Plan Commission

Agenda

SUBJECT: Recommendation regarding a Site Plan request at 1212 N. Enterprise Drive in De Pere for a warehouse addition and parking lot expansion (Parcels ED-2070 and ED-2069). Applicant: Mach IV Engineering & Surveying LLC

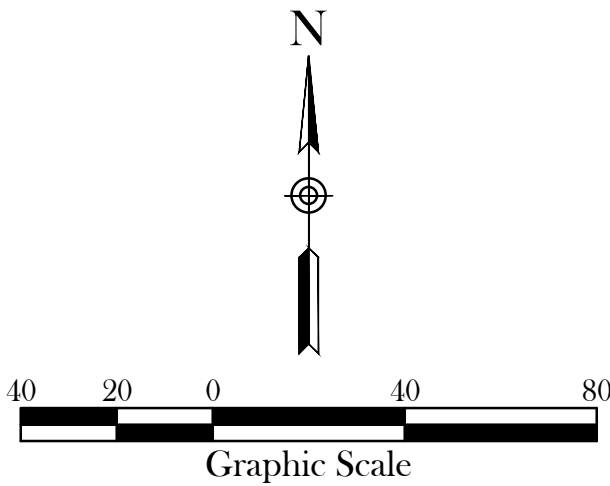
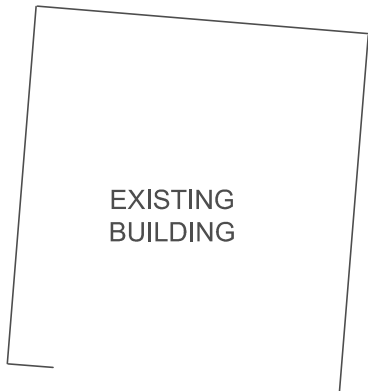
1. Existing Conditions Sheet C1.0 - Comment two says to remove/salvage "GRAVE" instead of "GRAVEL".
2. Pursuant to Municipal Code 14-60(9)(2)(h) need to show the dimensions of the adjacent right-of-way and roadway.

8. On the Existing Conditions Sheet C1.0, show the sanitary lateral and water service pertaining to comments 9 & 10. Verify they have adequate cover beneath the proposed western pond.

SITE PLAN

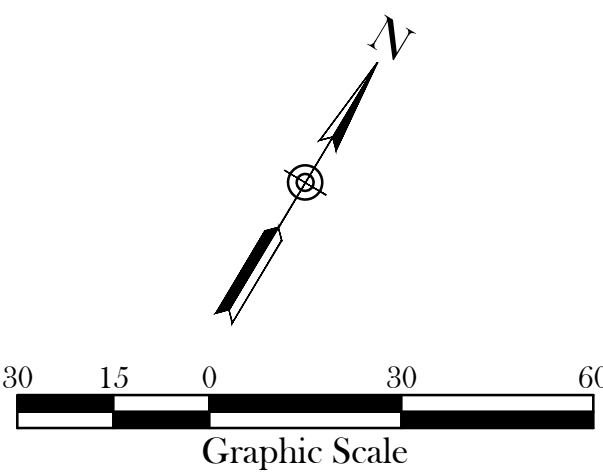
9. On the Site Plan Sheet C2.0 show adjustments for the water valve and the sanitary clean-out referenced in comments 9 & 10 on the Existing Conditions Sheet C1.0.

12. Update sheet key notes for the details on the Site Plan sheet C2.0.
13. Update the pond typical sections on the Erosion Control Plan sheet C5.1 (slopes).

14. Show the site address on the cover page. It is only found on sheet C2.0

UTILITY PLAN

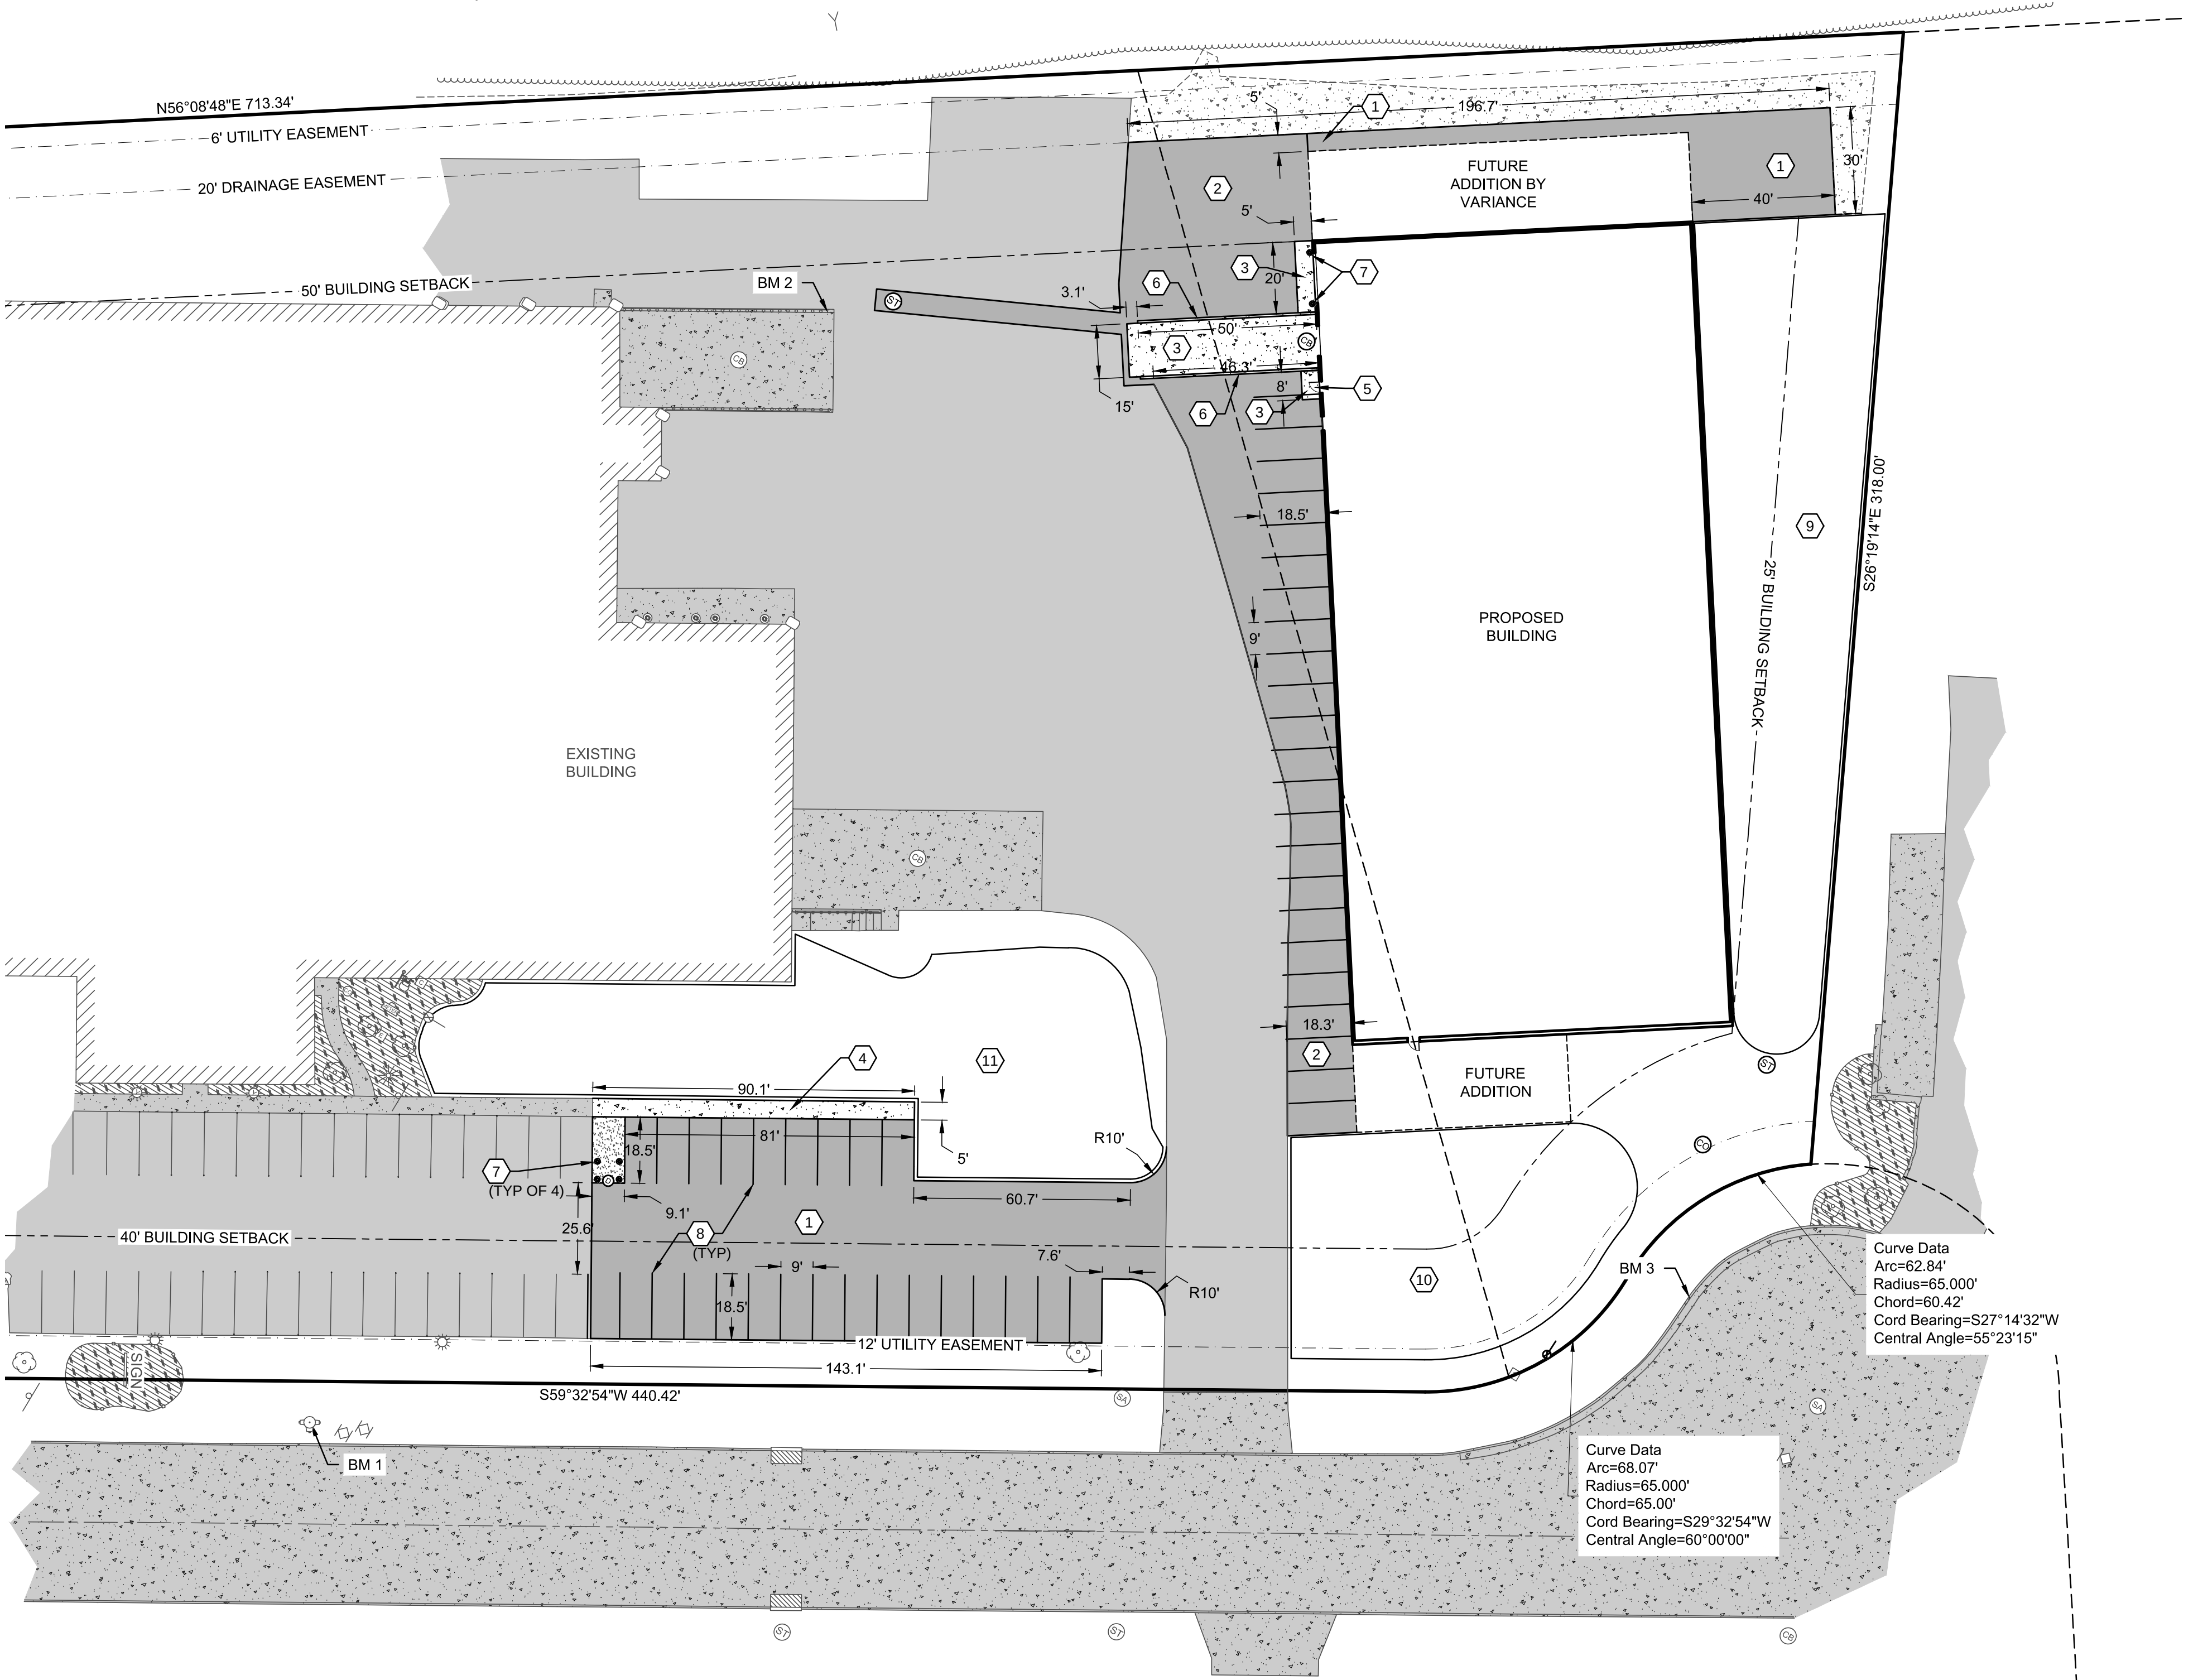
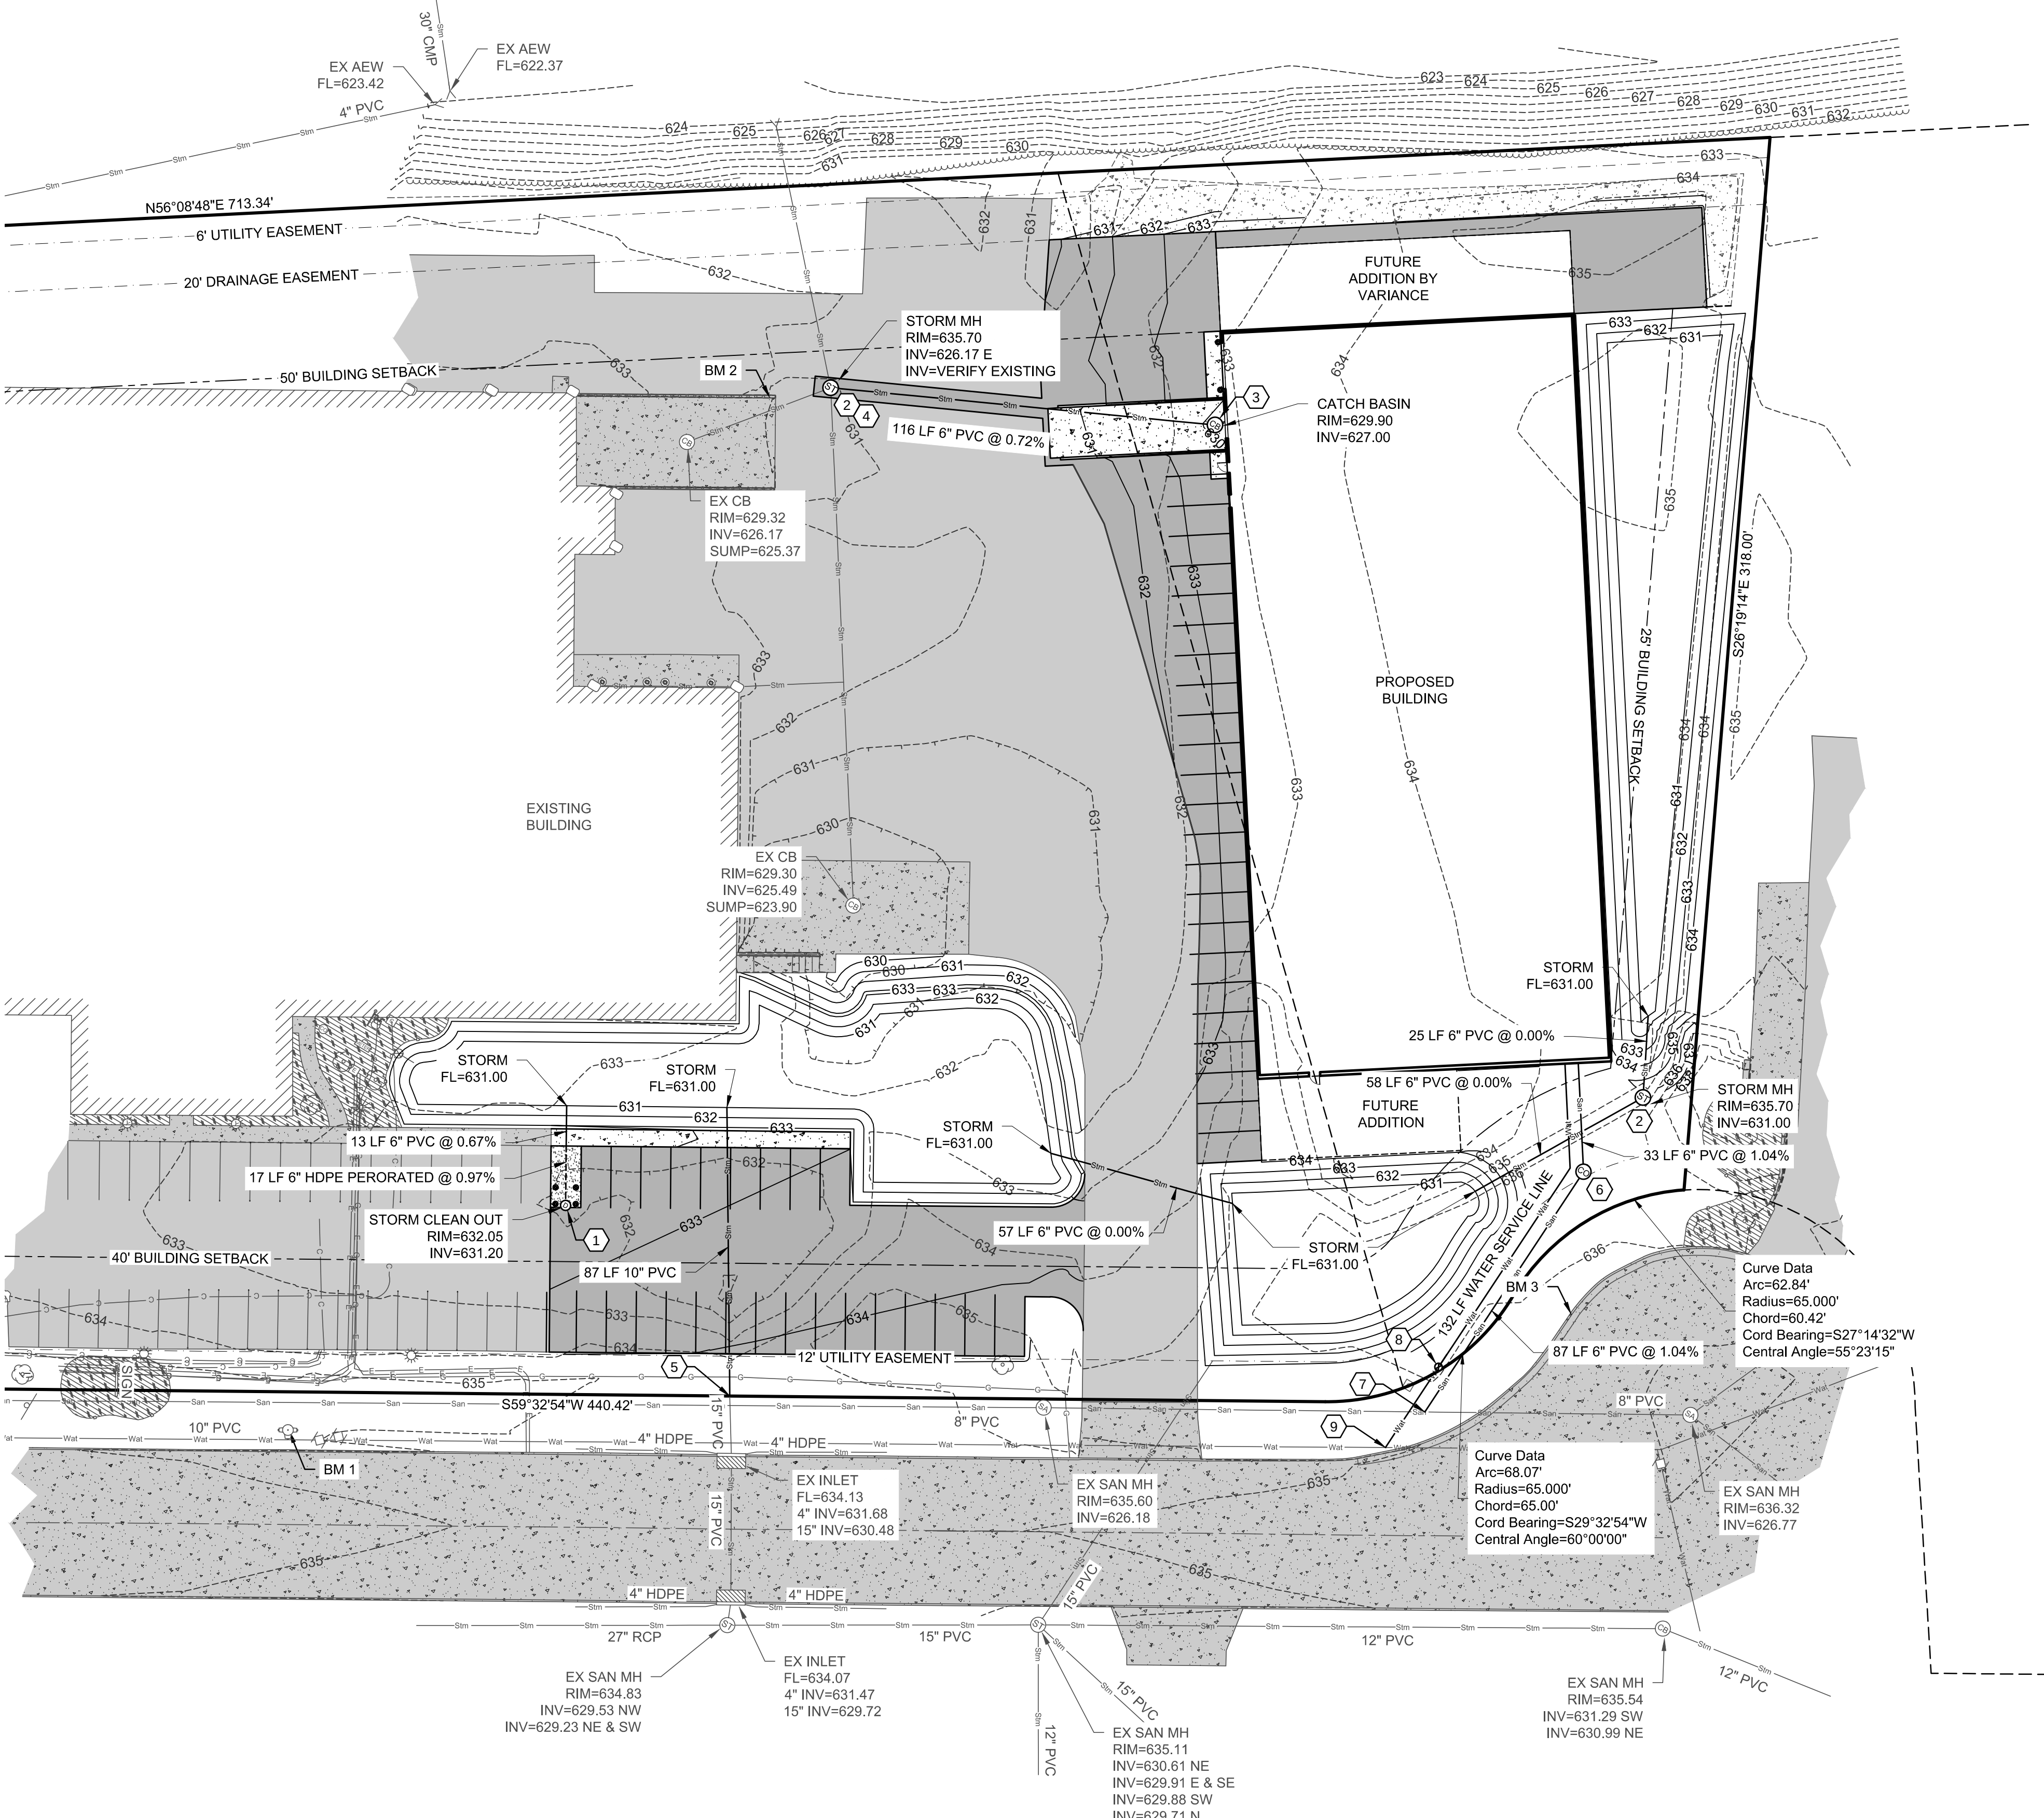
3. On the Utility Plan C3.0 need to have a comment to acquire an excavation permit with City of De Pere Public Works at 925 S. Sixth Street prior to excavating in the right-of-way and connecting the water service and sanitary service. Call Public Works at 920-339-4061.

4. On the Utility Plan C3.0 need to have a comment to contact the City of De Pere Water Department prior to connecting water service to the water main. They will need to be present at the time of connection. Call Water Department at 920-339-4063.

10. On the Utility Plan Sheet C3.0 show the old storm sewer lateral as capped like shown on the Existing Conditions Sheet C1.0 - comment 6.
11. On the Utility Plan Sheet C3.0, all PVC storm pipes need to have secured concrete end walls.
